June 9, 2020

G-4638

**Subject: ADDENDUM LETTER 5 – RESPONSE TO PLAN REVIEW COMMENTS
 PROPOSED DEVELOPMENT – LOWER BUILDING
 4270 EAST MERCER WAY
 MERCER ISLAND, WA**

PILE CALCULATION DETAIL

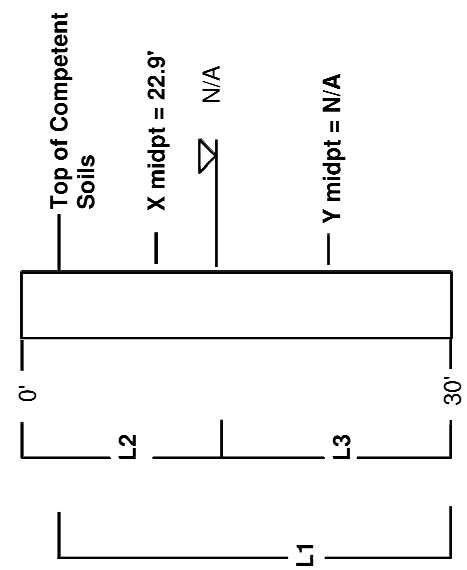
Include pile size and capacity used in the design of the foundations.

Geotechnical engineer to provide supporting calculations for pile capacity.
Include Factor of Safety in determining the allowable pile capacities.

Please see the attached **Plate A – Pile Calculation Detail** and **Plate B – Pile Calculation** which illustrate the pile calculations performed by GEO Group Northwest. Note that the factor of safety used for pile capacity is 3.0.

LOWER BLDG TEMP EXCAVATION
 PROPOSED DEVELOPMENT
 4270 E. MERCER WAY
 MERCER ISLAND, WASHINGTON

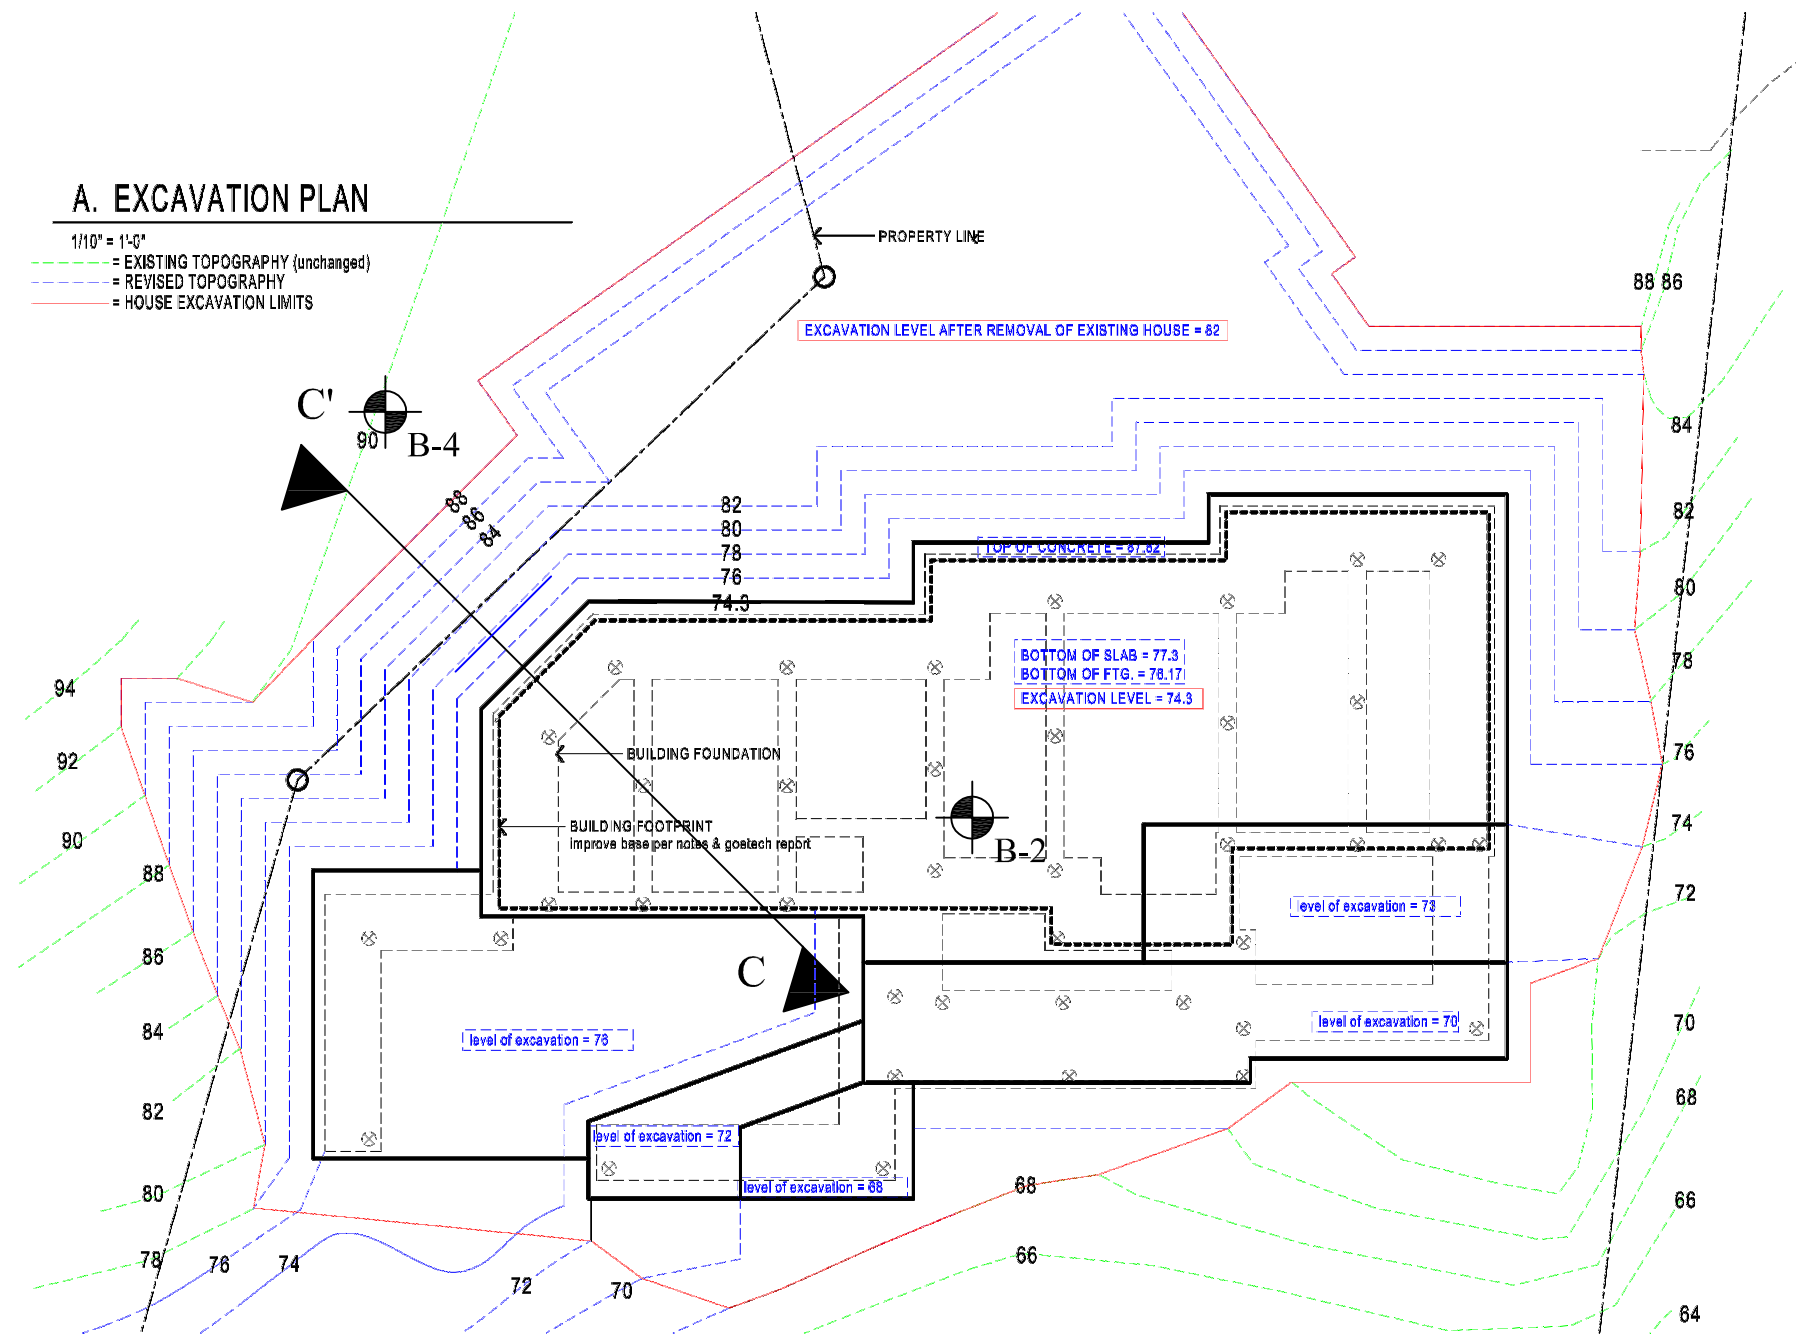
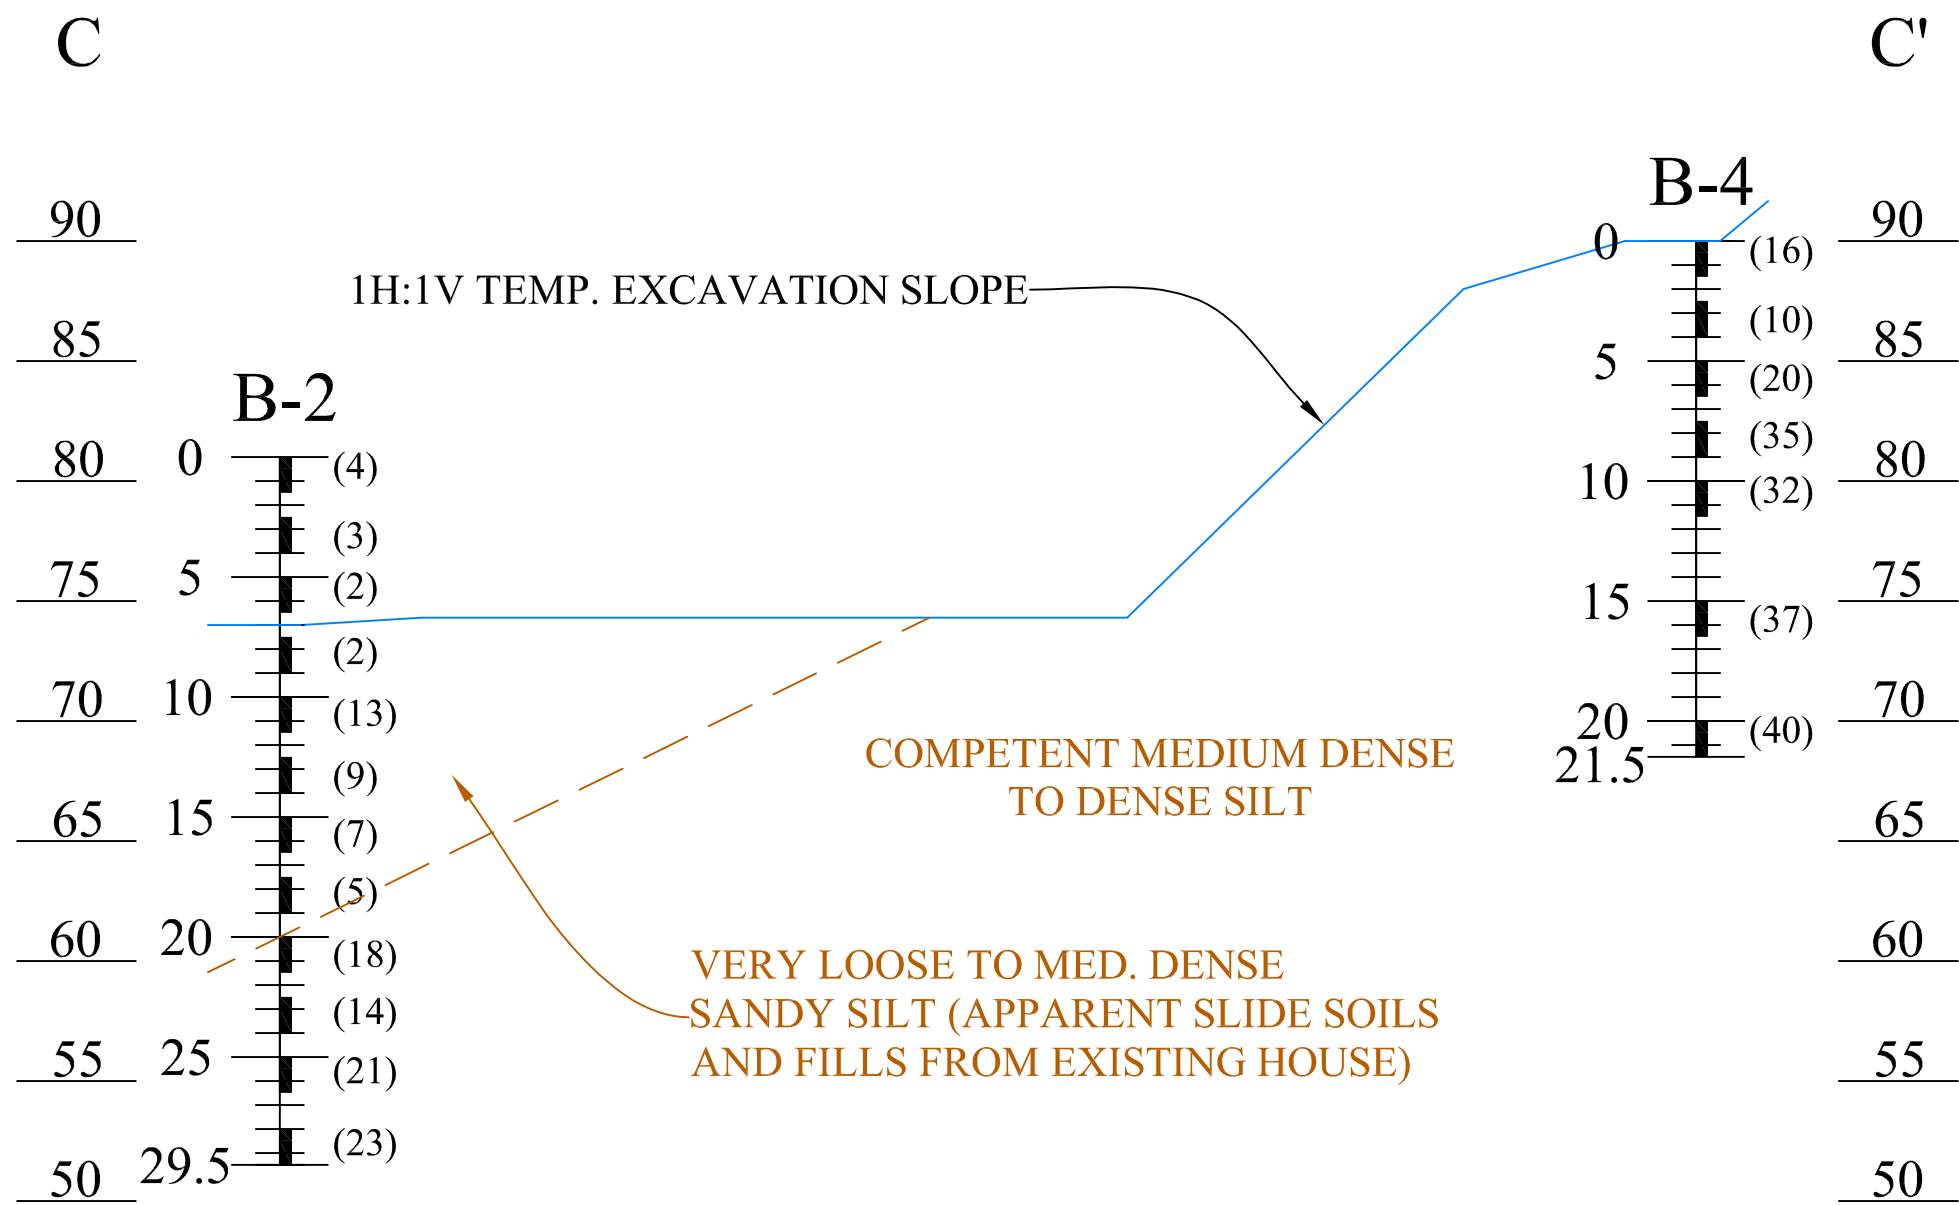
Provide slope stability analyses of this temporary cut with the existing slope above it. Include condition of 3 foot overexcavation below the slab in the slope stability section.

The temporary cut in question is the proposed building basement excavation at the uphill side of the excavation. The designer provided a revised temporary excavation plan as shown on the attached **Plate C – Lower Bldg Temp Excavation** which we used to develop our cross-section C – C' as shown on the attached **Plate D – Cross-Section C – C'**. The designer's temporary excavation plan includes the 3-feet of over-excavation. GEO Group Northwest has performed slope stability analysis for the cross-section C – C' and the output of that analysis is attached as **Plate E – Slope Stability Output C – C'**. Results from the slope stability analysis indicate that

the temporary excavation slope is sufficiently stable for a temporary construction related excavation having a factor of safety equal to 1.3.

STORM TRENCH - STABILITY
 4270 E. MERCER WAY
 MERCER ISLAND, WASHINGTON

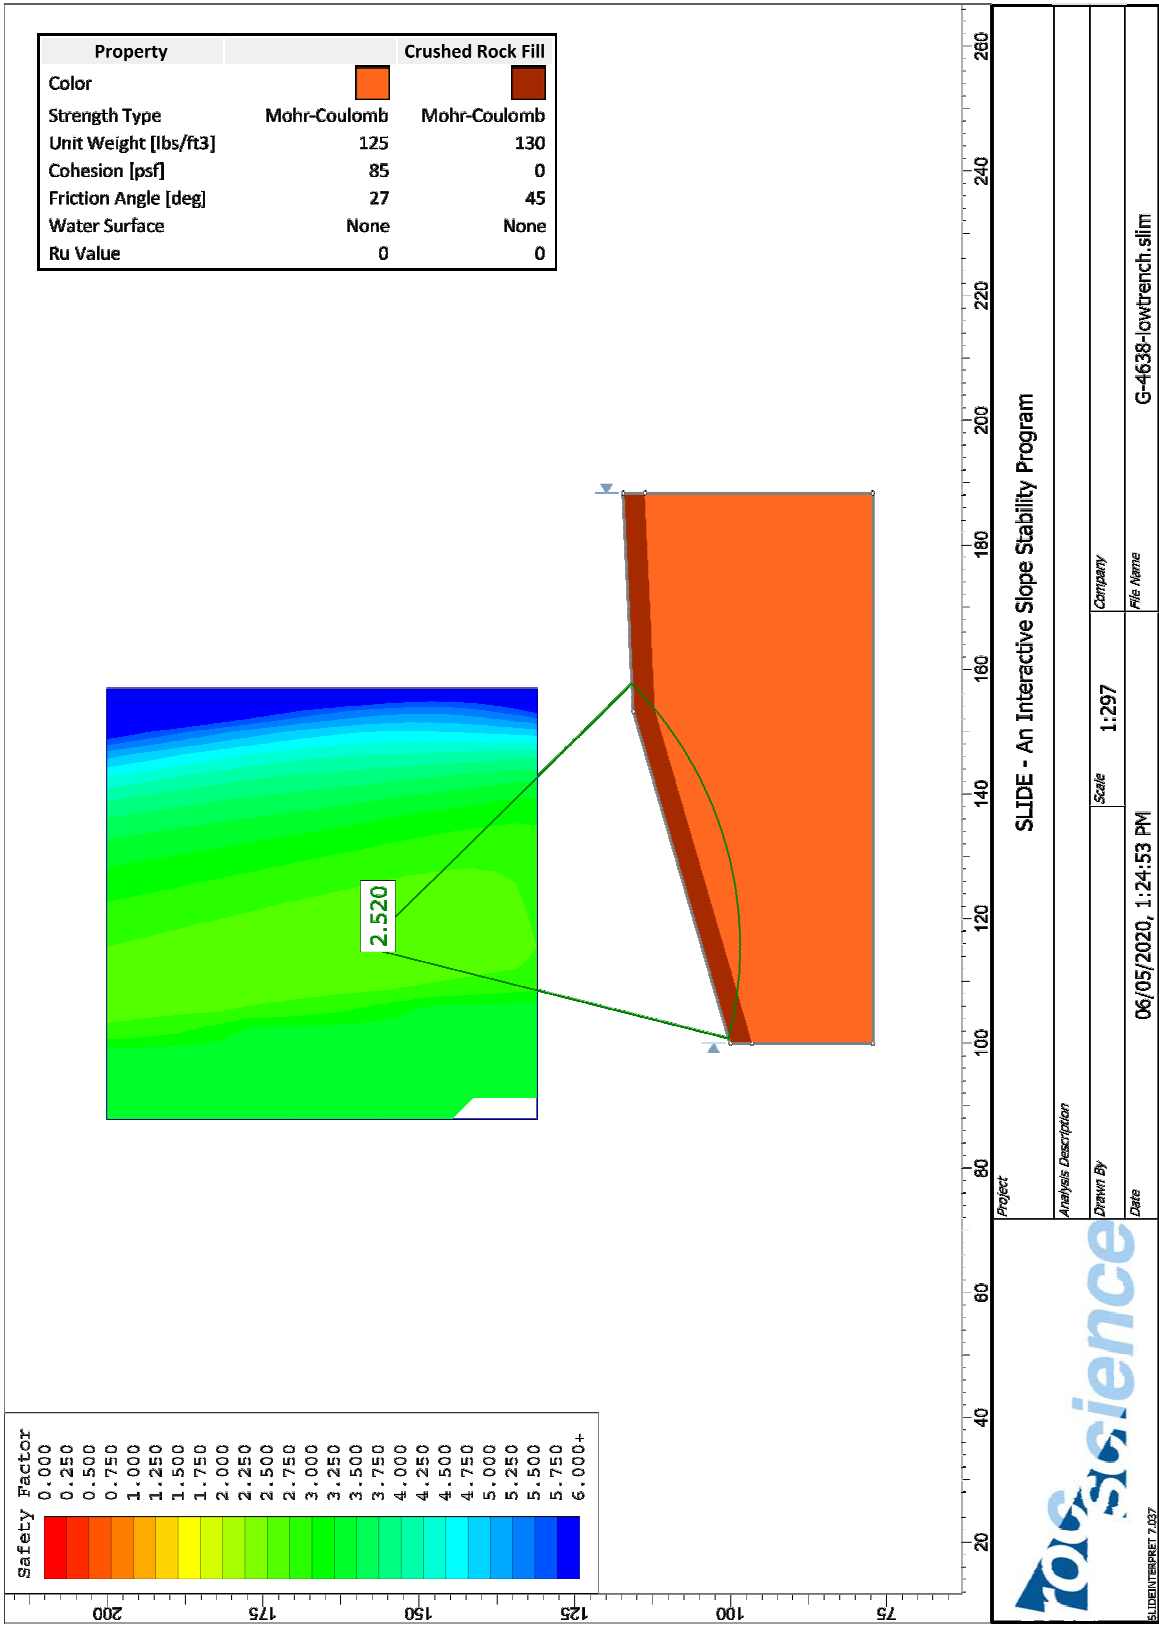
Geotechnical engineer to assess potential impact of new storm installation on existing slope stability. Provide section and stability analyses to support conclusions.

For the proposed 12-inch diameter stormwater installation at the lower building lot we have performed slope stability analysis along the trench profile illustrated on the CES plan sheet C2.0. The output of our stability analyses for this profile is shown on the attached **Plate F – Storm**

Trench – Stability. Stability analysis indicates that the backfilled trench is stable having a factor of safety equal to 2.5.
